Thomas A. Dewire, Jr.  
James Michael Dewire  
Trustees, Dewire Family Trust

May 16, 2013

Re: Curb Cut Application, 93 Kirkland Street (the "Application").

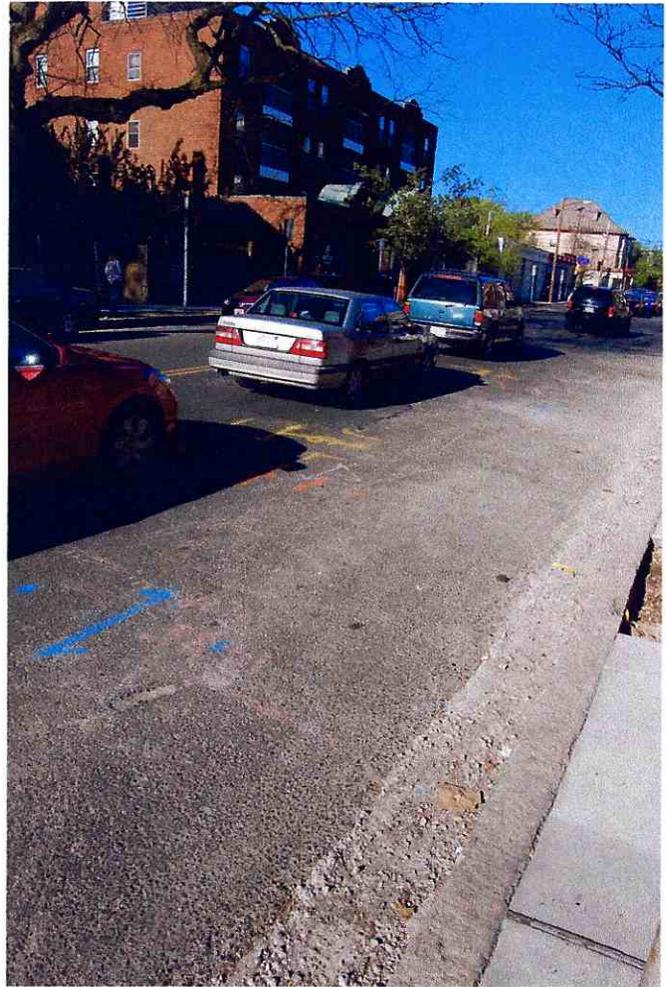
3. The proposal also violates the 25' offset between the proposed driveway and any intersections (**6.43.4(b)**). Specifically, the proposed curb cut lies within 25' of (a) the intersection of Kirkland Street and Washington Street, Somerville (b) the intersection of Kirkland, Washington, and Line Streets (Cambridge, Somerville) and (c) Levy Road (**6.43.4(b)**). This is already a highly congested intersection which will only see worse days as commuters to and from the millions of square feet of office, lab, educational, and retail space in East Cambridge seek alternate routes.

5. *"To reduce hazard to pedestrians on public sidewalks"* (**6.11**) (**6.43.4(c)**). There is zero visibility from this proposed driveway towards Somerville to both pedestrians and oncoming traffic due to a 6' wooden fence resting on top of 0.9' wide concrete strip wall (Due North Land Surveying, February 28, 2003). DPW specifications call for "minimum 20-foot visibility in both directions for motorists entering the roadway or crossing a public sidewalk" (TP&T Building Permit Review Guidelines, 2007.) The proposal violates the Guidelines.
